**802.3bj D3.0 sponsor ballot
comment i-122
Revision 1a**

- Supporting presentation D3.0 sponsor ballot comment i-122
- Review achievability of 802.3bj D3.0 mated test fixture specifications.

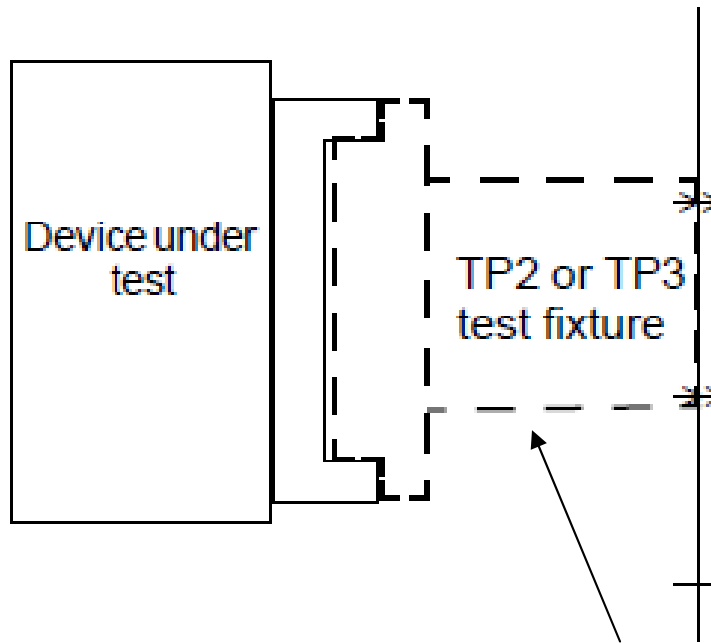
<i>Cl</i> 92	<i>SC</i> 92.11.3.2	<i>P</i> 224	<i>L</i> 23	<i>#</i> i-122
Palkert, Thomas		Molex Incorporated		
<i>Comment Type</i>	G	<i>Comment Status</i>	X	
MCB's and HCB's that are within reasonable manufacture impedance tolerances (~5%) can fail the 92.11.3.2 Mated test fixtures return loss specifications. Change 92.11.3.2 Mated test fixtures return loss specifications to proposed limits. See supporting presentation				
<i>Suggested Remedy</i>				
Change 92.11.3.2 Mated test fixtures return loss specifications to..				
Return loss(f) >=				
20-1.429*f 0.01 <= f < 4.9 GHz				
14.4-0.286*f 4.9 <= f < 10.85 GHz				
12.05-51.1*log(f/10.5) 10.85 <= f < 13.8 GHz				
5 13.8 <= f <= 25 GHz				
<i>Proposed Response</i>	<i>Response Status</i> O

QSFP28 MTF IL

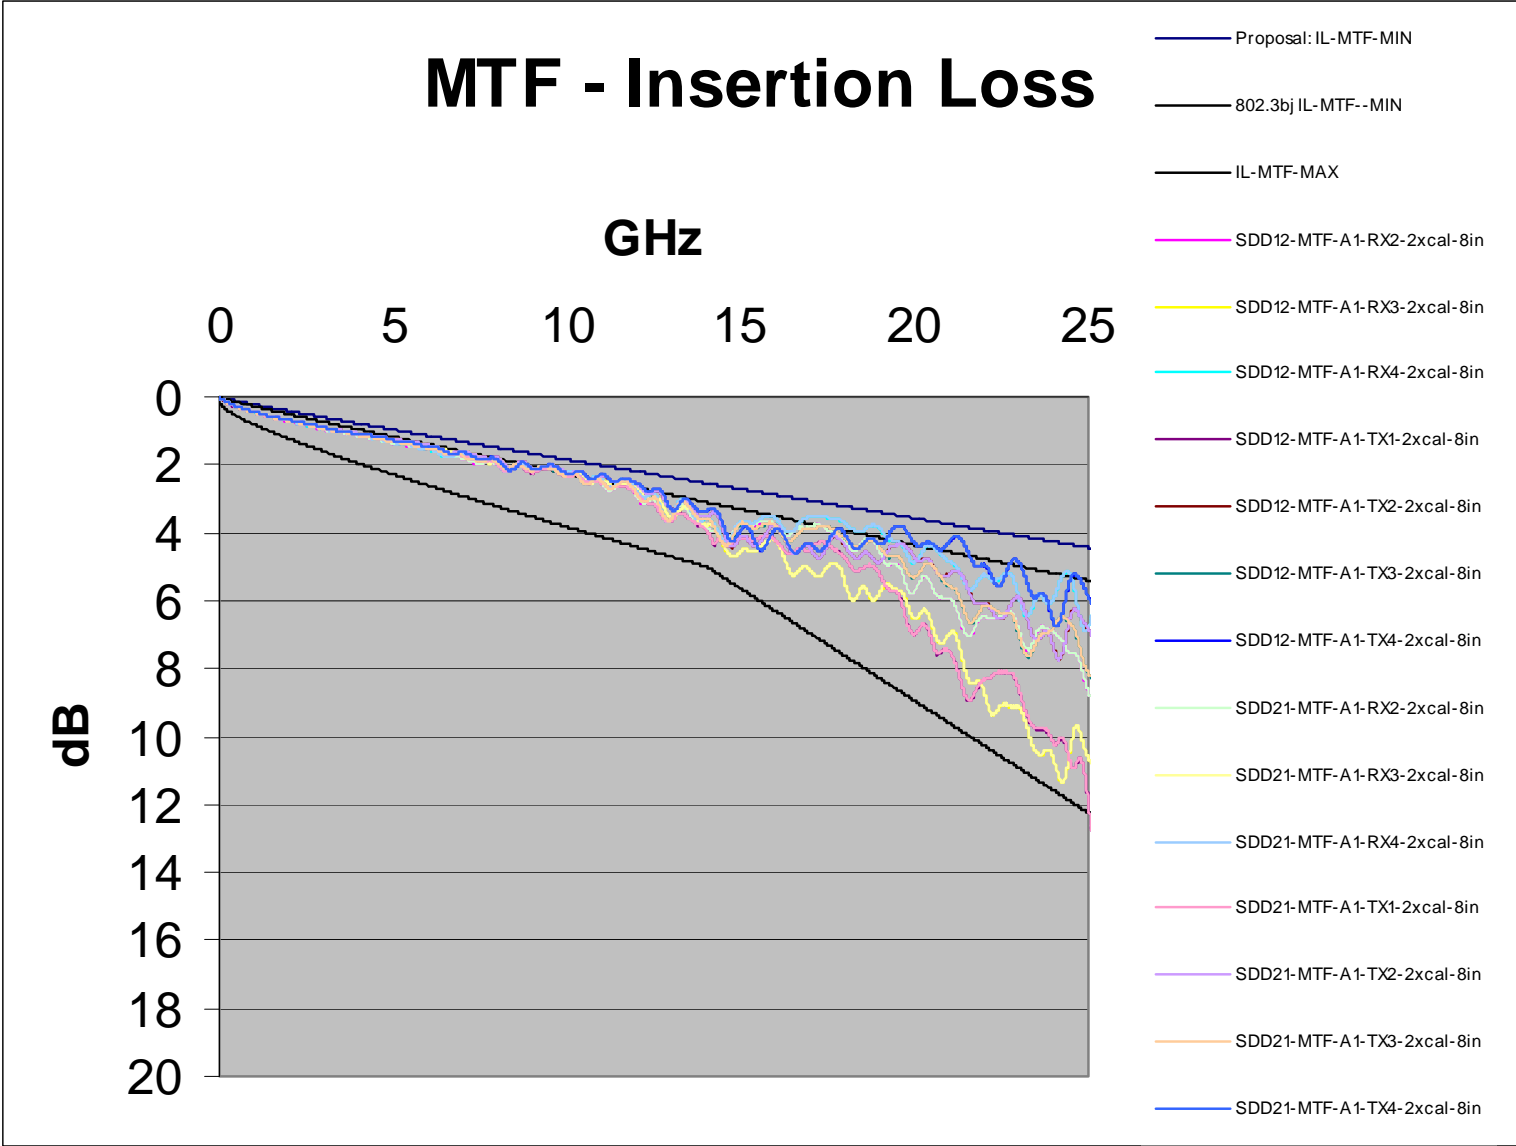
Proposal: $IL(f) \geq IL_{MTFmin} = 0.0656 * \sqrt{f} + 0.164 * f$ $0.01 \leq f \leq 25$ GHz

Change (92-44) to:

$$IL(f) \geq IL_{MTFmin} = 0.0656 * \sqrt{f} + 0.164 * f \quad 0.01 \leq f \leq 25 \text{ GHz}$$

TP2/TP3 test fixture reference insertion loss proposal

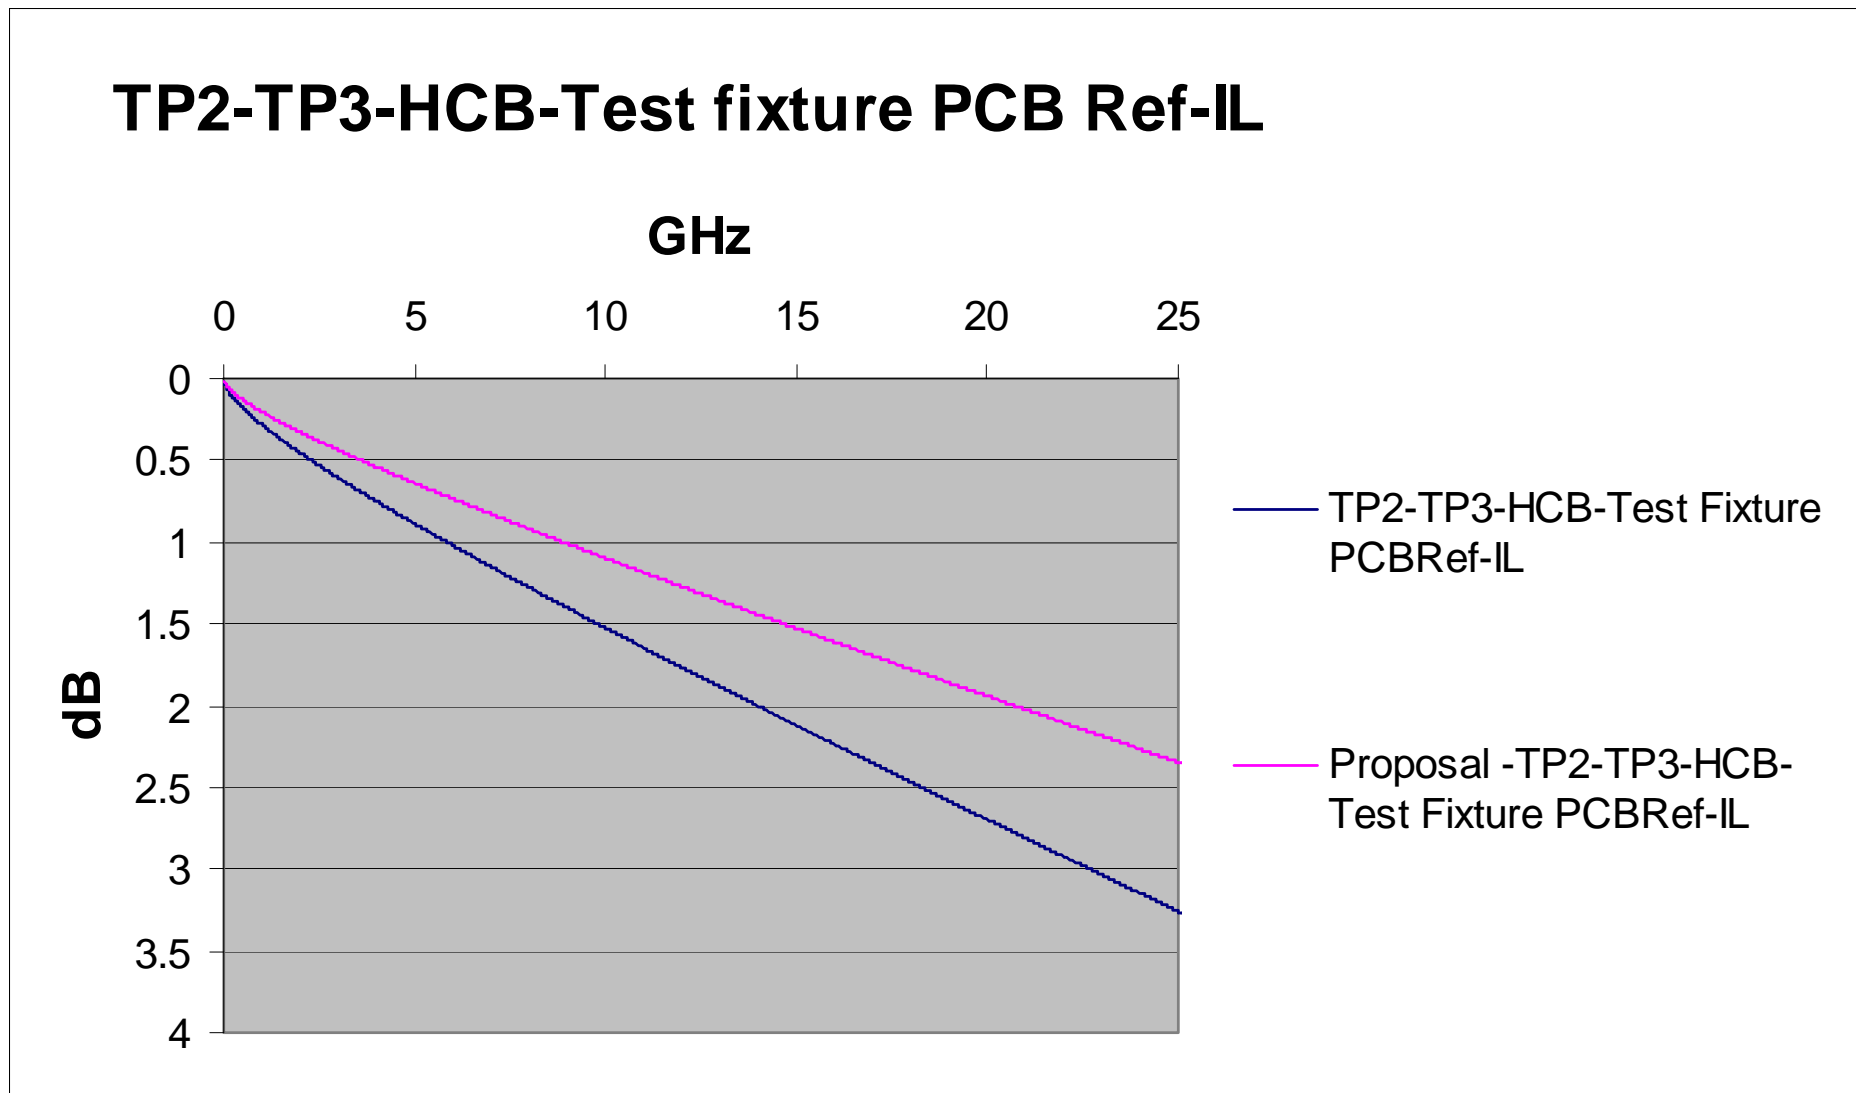
- Change TP2/TP3 test fixture PCB reference insertion loss
- $IL_{\text{tfref}}(f) = -0.00144 + 0.13824\sqrt{f} + 0.06624f$
